Caballos De Oro Estates

TECHNICAL DRAINAGE STUDY

Addendum 1

SUBJECT: TECHNICAL DRAINAGE STUDY FOR CABALLOS DE ORO ESTATES
CLV DS 4811A
ADDENDUM 1

CABALLOS DE ORO ESTATES
GRADING PLAN

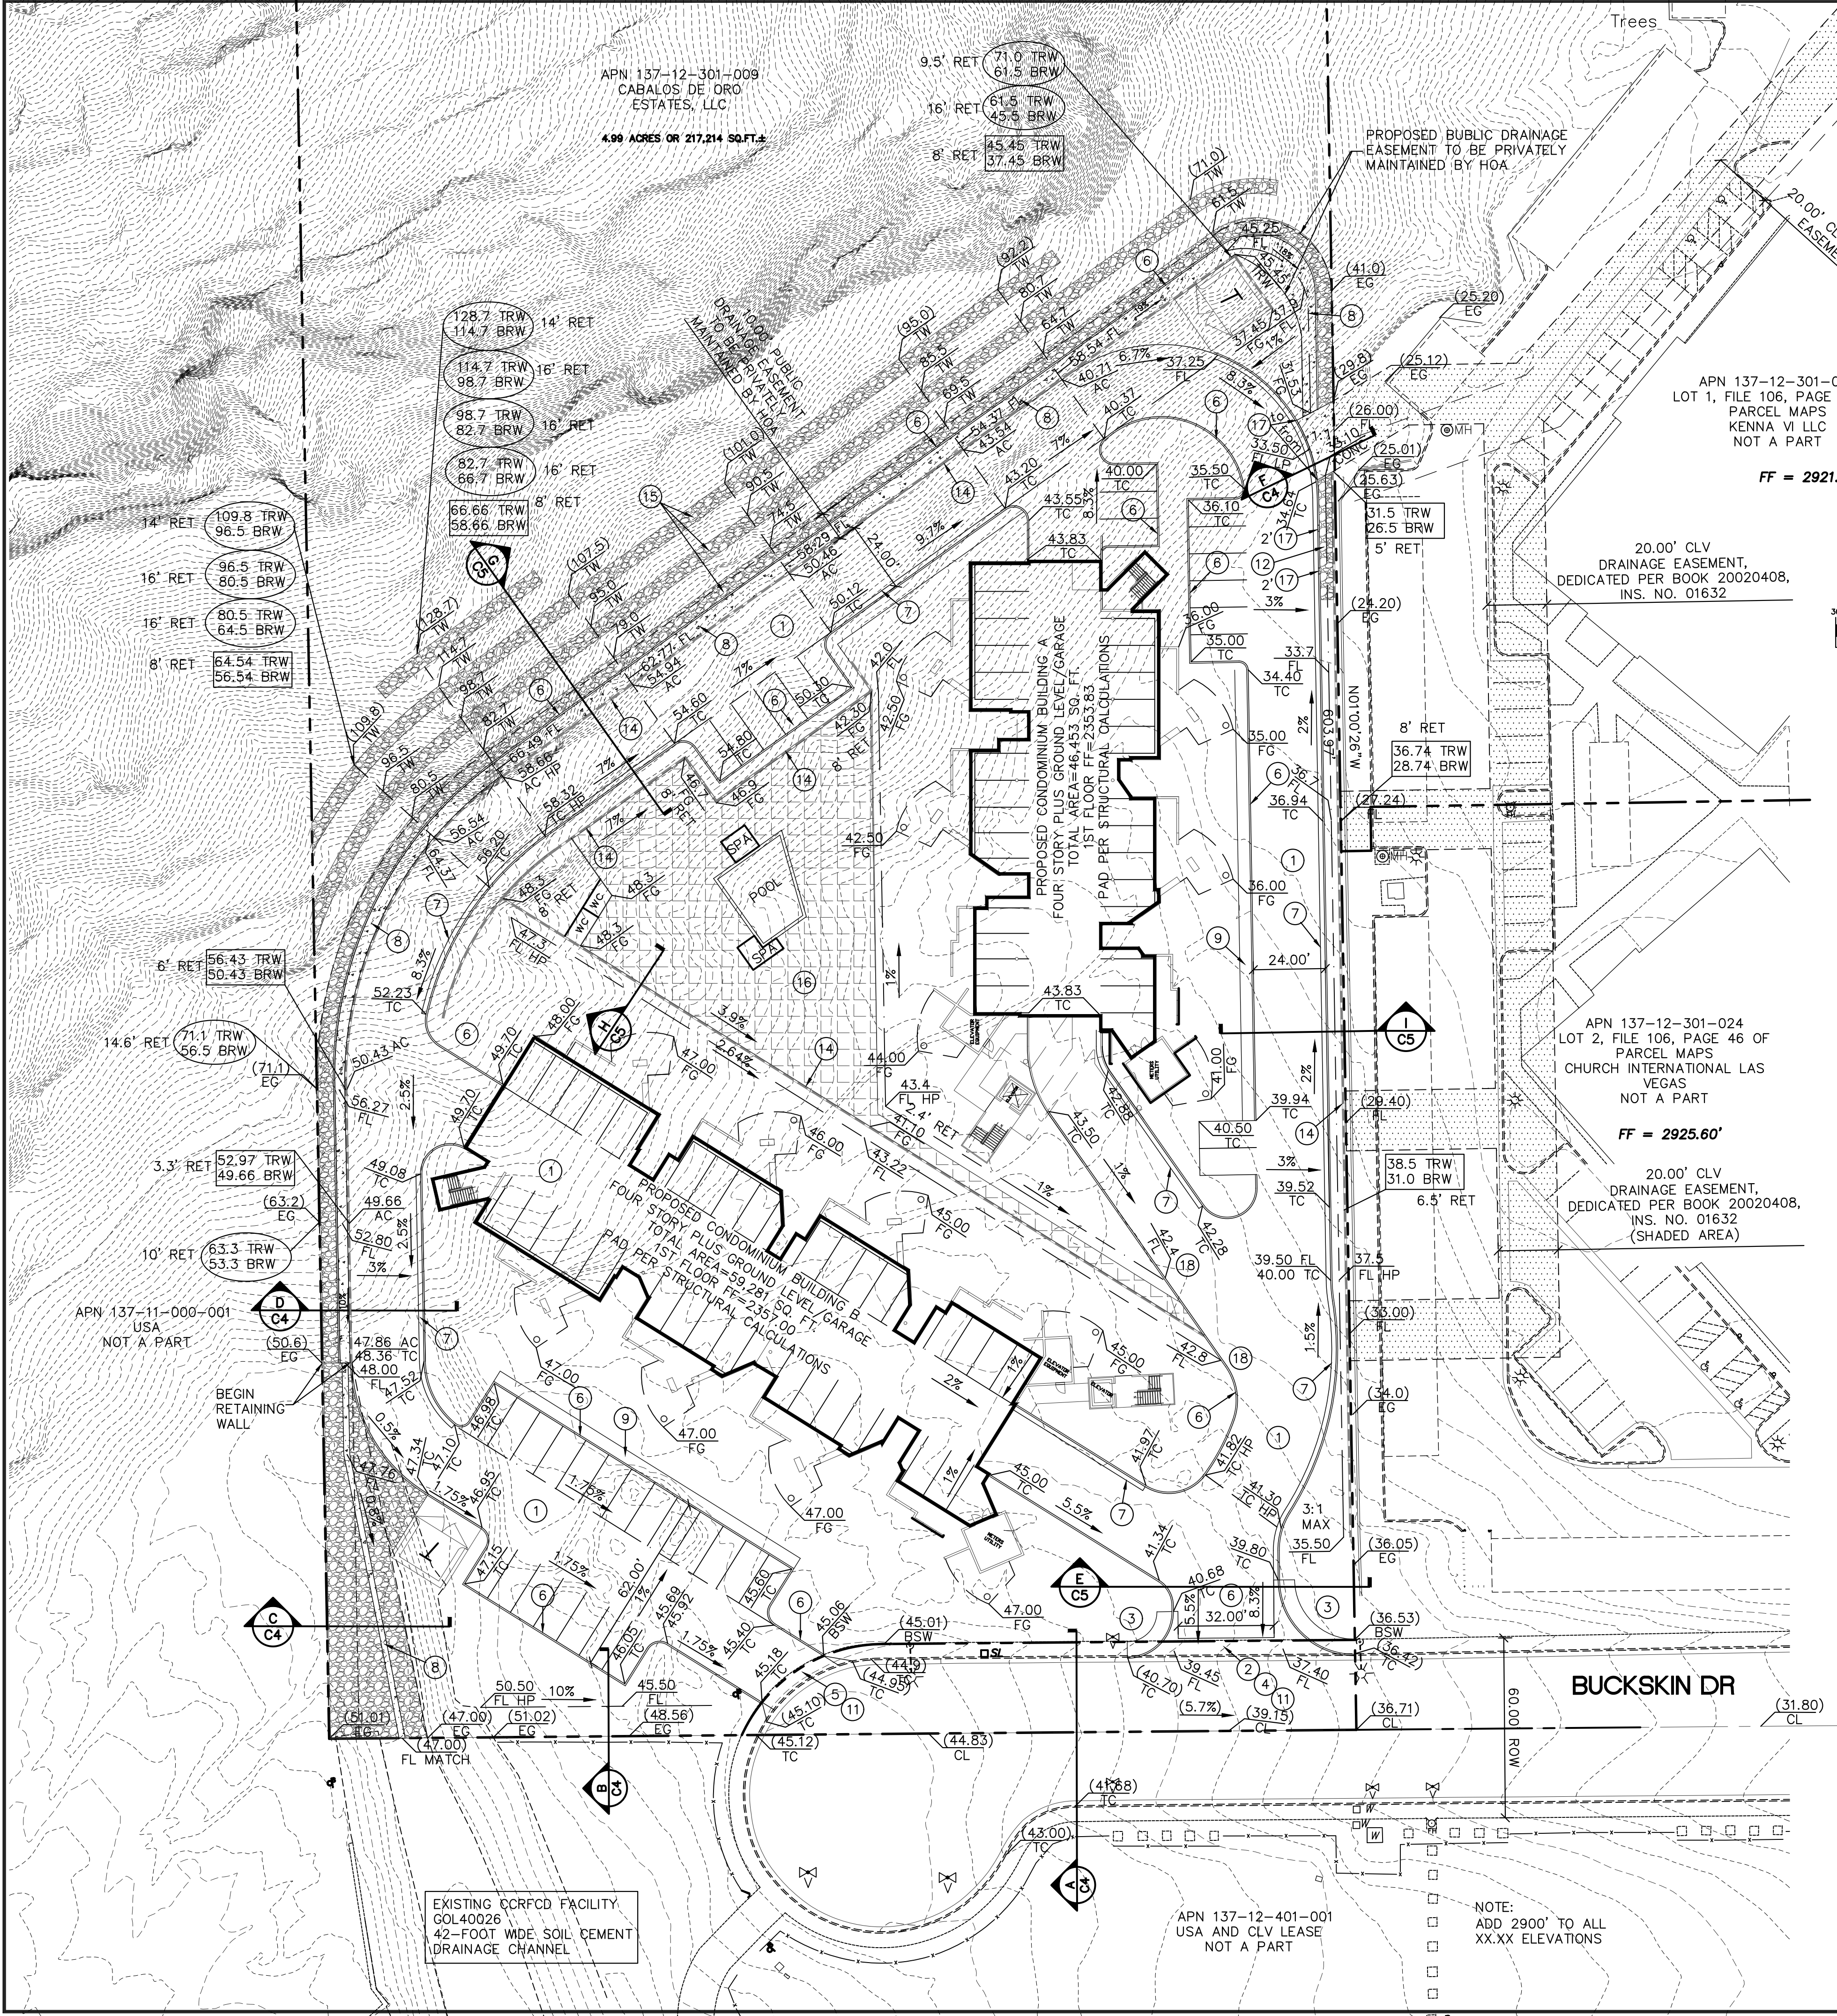
8. Identify and label an existing drainage easement in the adjacent property to the east with recorded document number on the grading plan.

Identify and label an existing drainage easement in the adjacent property to the east with recorded document number on the grading plan.

The recorded document number was added to the Grading Plan and a copy is attached.

ONSITE DRAINAGE MAP
(DEVELOPED CONDITION)

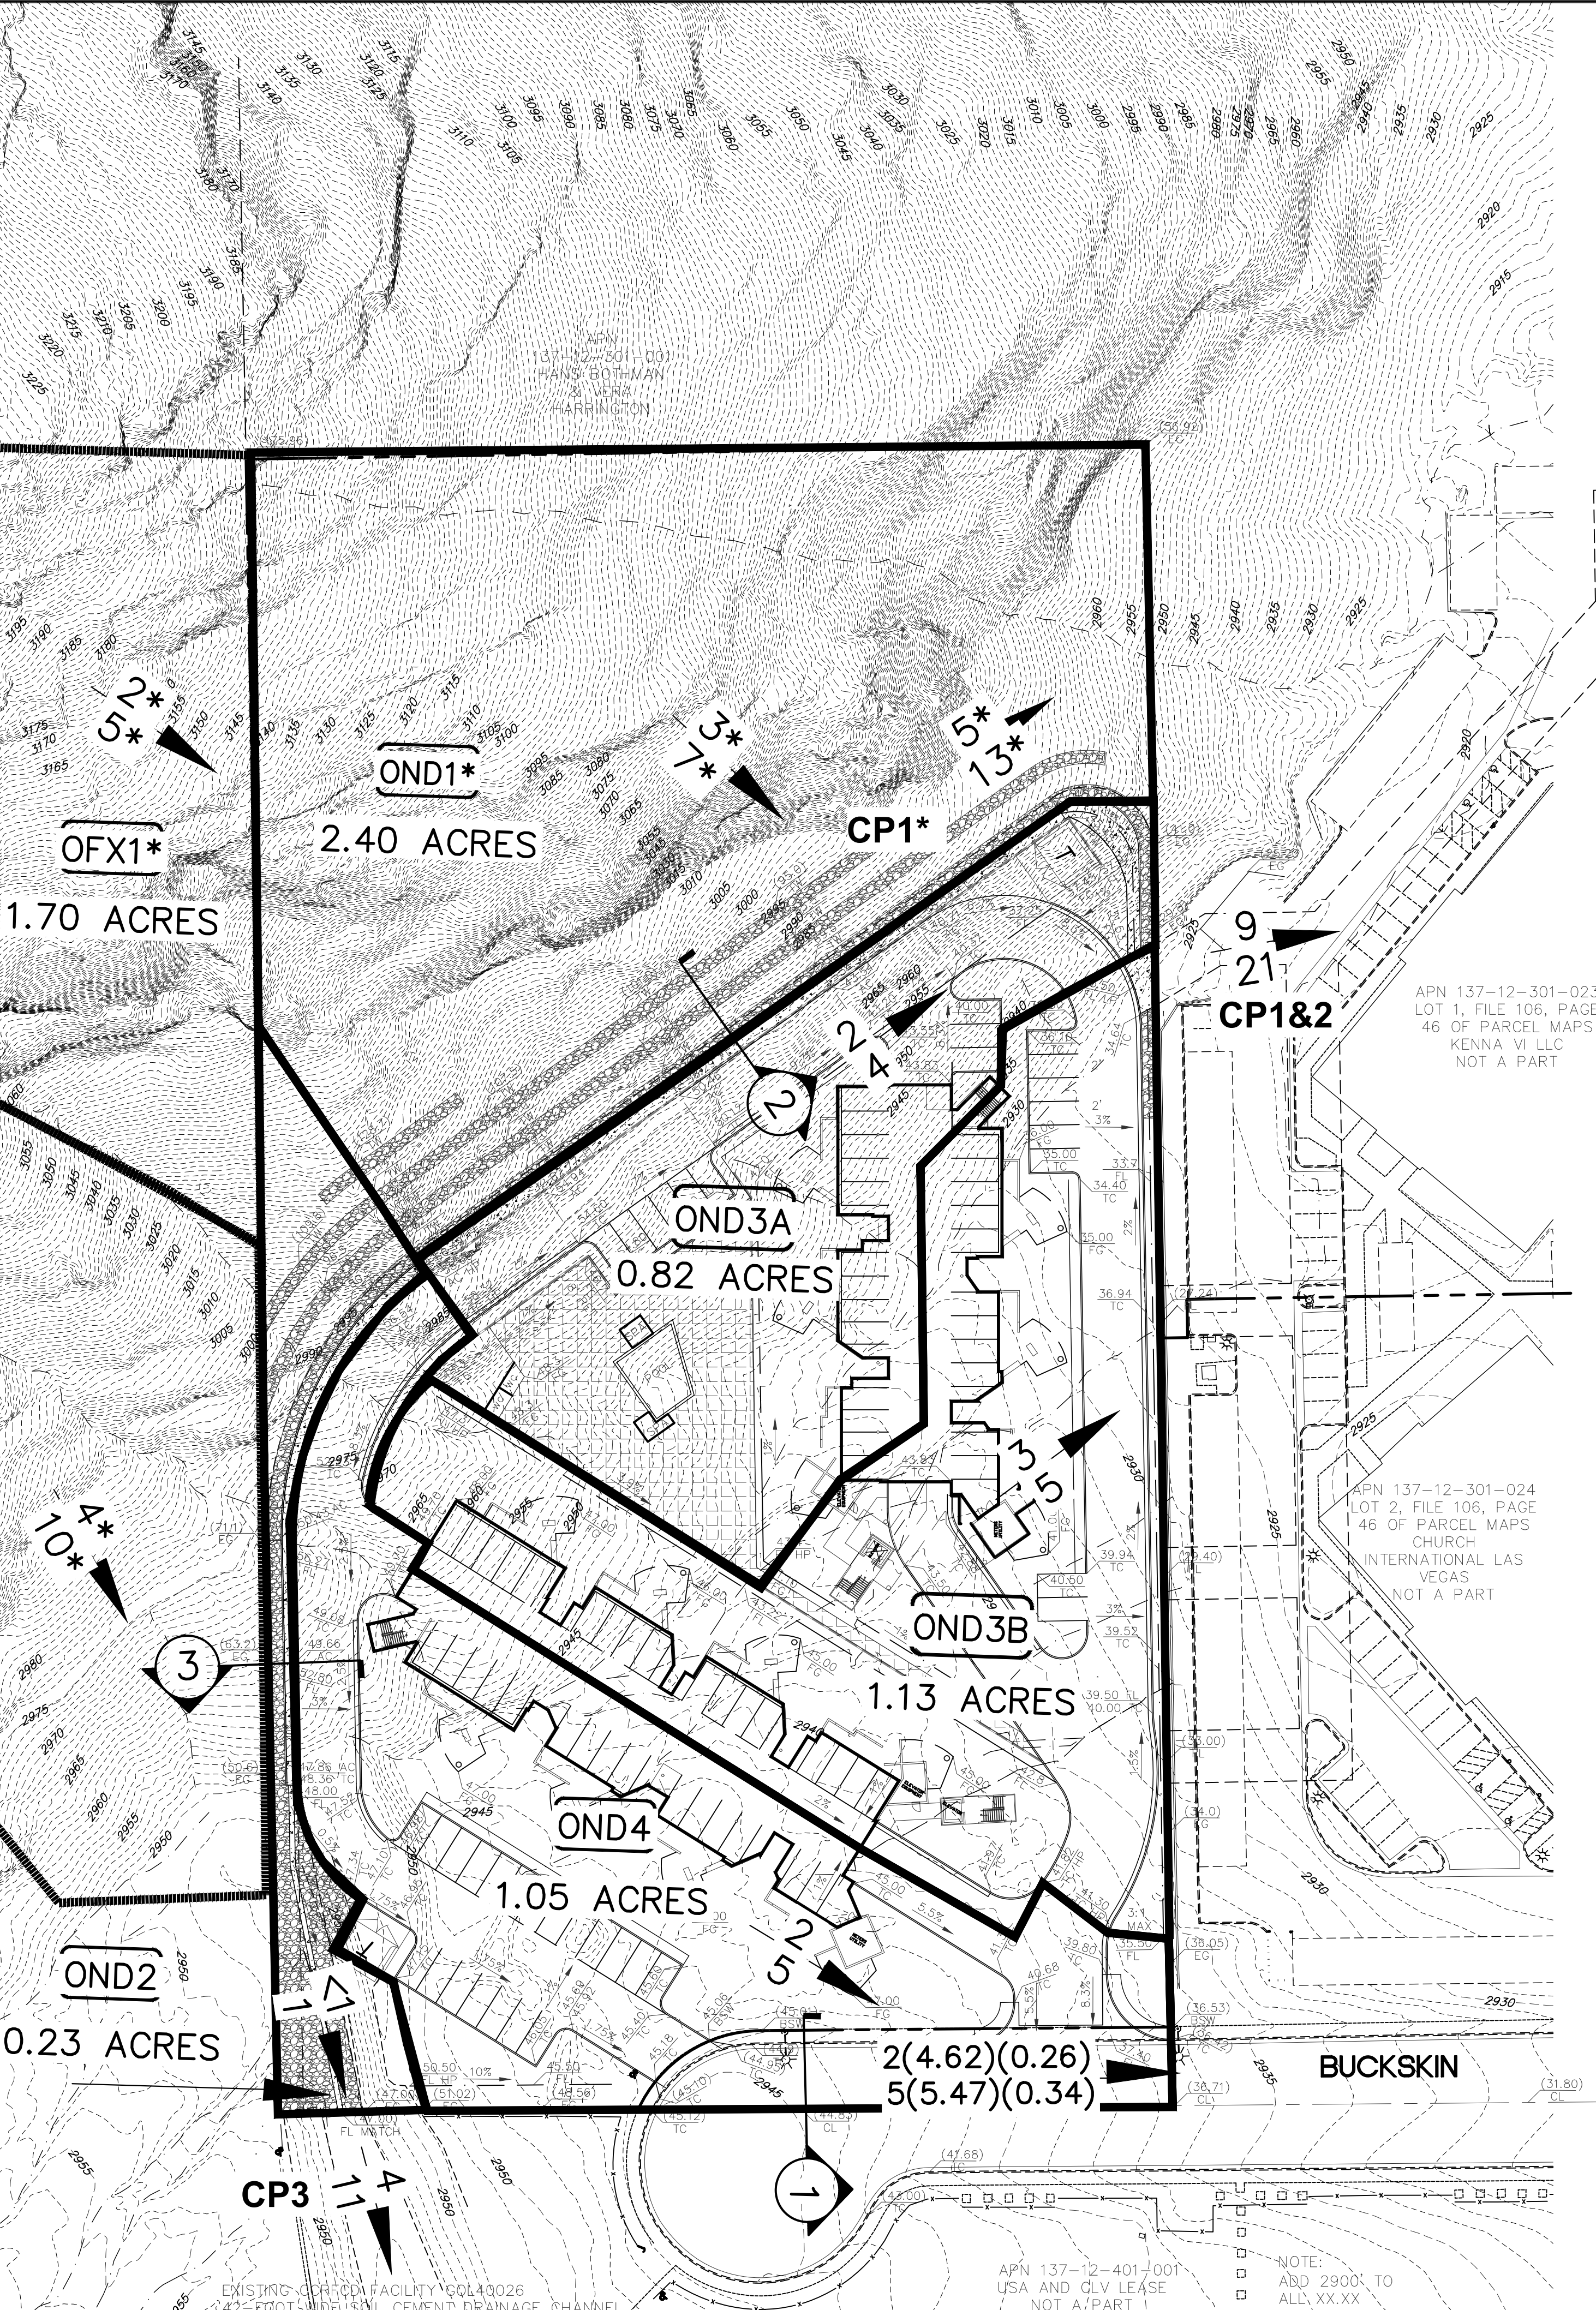
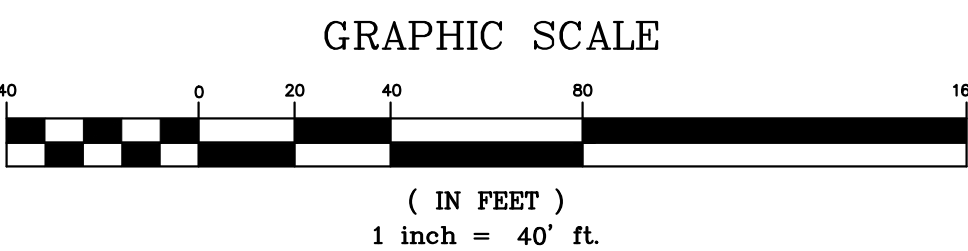
5. On the **Onsite Drainage Map (Developed Condition) Sheet D1:**

- Identify and label basins "OFX1", "OND1" and concentration point "CP1" which are missing in the last submittal.
- The flow summary for *Hydraulic Sections 1, 2 and 3* are missing in the last submittal. Provide as such in the next submittal.
- It appears that the northern half of the west property line of the subject development is used as a basin boundary for "OFX1". However, the west property line is not a logical basin boundary. Review and revise the offsite basins accordingly.
- The scale of the proposed onsite drainage map is not adequate. Use a larger scale to include the whole scope of the onsite and offsite basins.

On the Onsite Drainage Map (Developed Conditions) Sheet D1:

- *Identify and label basins "OFX1", "OND1" and concentration point "CP1" which are missing in the last submittal*
- *The flow summary for Hydraulic Sections 1, 2 and 3 are missing in the last submittal. Provide as such in the next submittal.*
- *It appears that the northern half of the west property line of the subject development is used as a basin boundary for "OFX1". However, the west property line of the subject development is used as a basin boundary. Review and revise the offsite basins accordingly.*
- *The scale of the proposed onsite drainage map is not adequate. Use a larger scale to include the whole scope of the onsite and the offsite basins.*

Sheet D1 has been revised as requested and a copy is attached.
